SUBDIVISION COMMITTEE
METROPOLITAN AREA PLANNING COMMISSION

STAFF REPORT
(One-Step Final Plat)

CASE NUMBER: S/D 98-67 - EAGLE RIDGE ADDITION

LOCATION: South side of 79th St. South, East of Ridge

VICINITY MAP

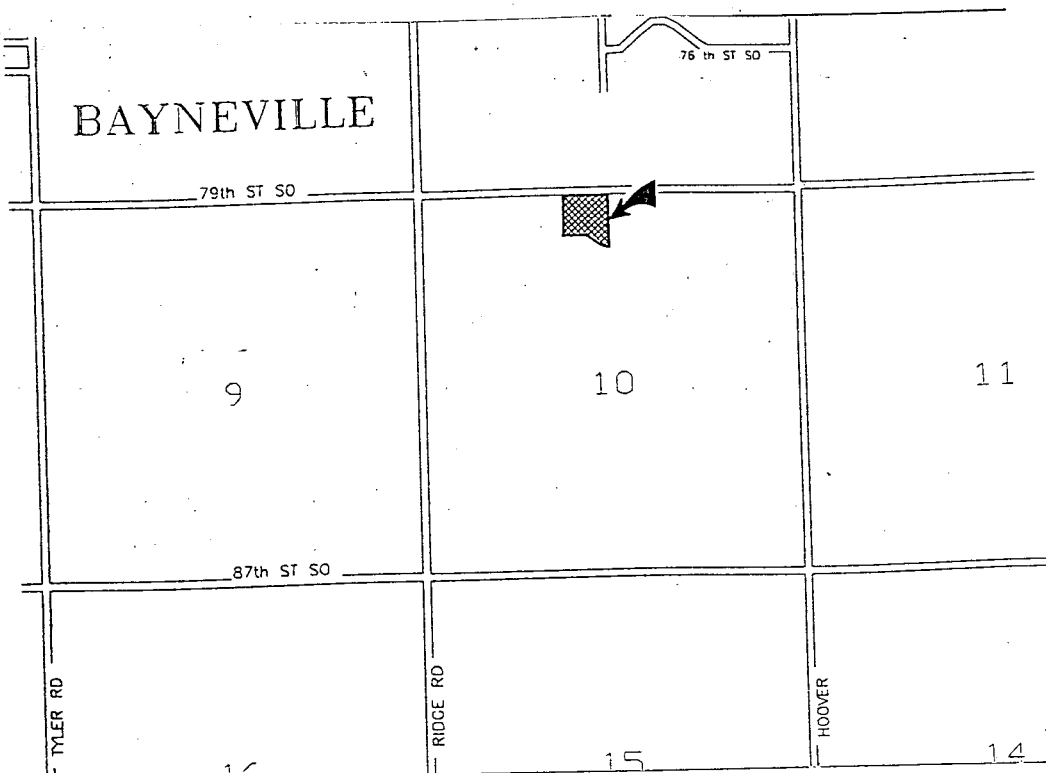
- C. County Engineering needs to comment on the status of the applicant's drainage plan.
- D. The plat denotes two access openings along 79th Street South. County Engineering needs to indicate if these access controls are acceptable.

- E. The applicant shall provide a covenant for the Floodway Reserve which provides for ownership and maintenance of the Reserve. The covenant shall grant, to the County, the authority to maintain the drainage reserves in the event the owner(s) fail to do so.

- F. The legal description needs to be revised to accurately portray the land being platted. The distance denoted for the north line of the plat on the face of the plat does not correspond with the legal description in the plat's text.

- G. The City Council signature block needs to be deleted as this plat is located beyond three miles of the City.
- H. The applicant shall install or guarantee the installation of all utilities and facilities which are applicable and described in Article 8 of the MAPC Subdivision Regulations. (Water service and fire hydrants required by Article 8 for fire protection shall be as per the direction and approval of the Chief of the Fire Department.)
